MIL-R-71135(AR)
AMENDMENT 2
14 September 1994
SUPERSEDING
AMENDMENT 1
8 December 1992

MILITARY SPECIFICATION

RIFLE, 5.56MM: M16A2E3

FIGURE I. Targeting and accuracy diagram.

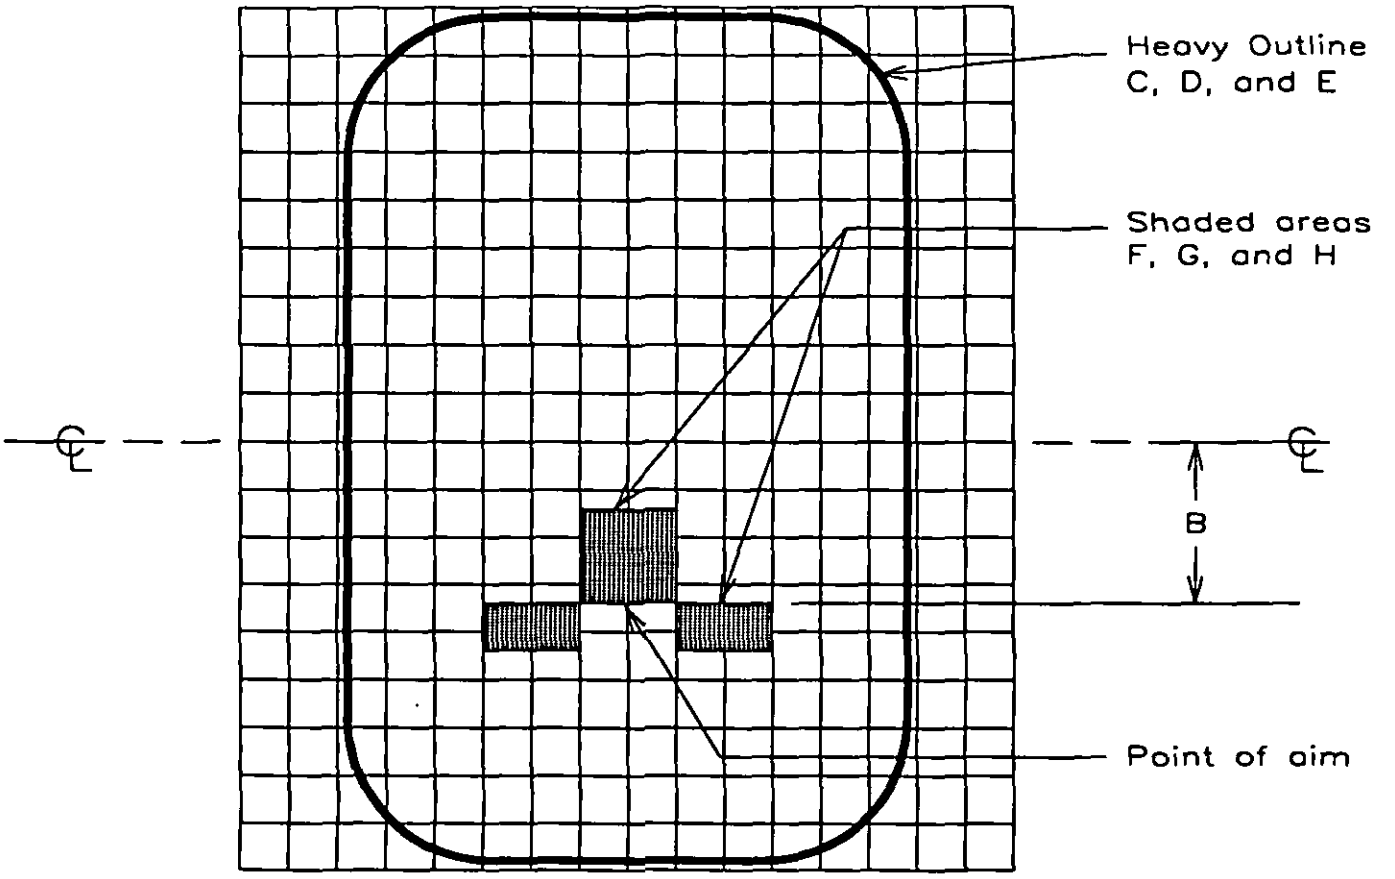
Figure I: Delete in its entirety and substitute the following:

A – 10 shot group extreme spread
B – Vertical distance from target centerline to point of aim
C – Height of heavy outline
D – Width of heavy line
E – Radius of corners of heavy outline
F – Width of shaded areas
G – Height of upper shaded area
H – Heights of lower shaded areas
I – Grid dimensions

Target Diagram For		Dimensions in inches								
		Group	P.O.A.	Heavy Outline			Shaded Areas			Grid
Meters	Yards	A	B	C	D	E	F	G	H	I
91.4	100	5.0	3.5	17.6	11.6	2.8	2.0	2.0	1.0	1.0
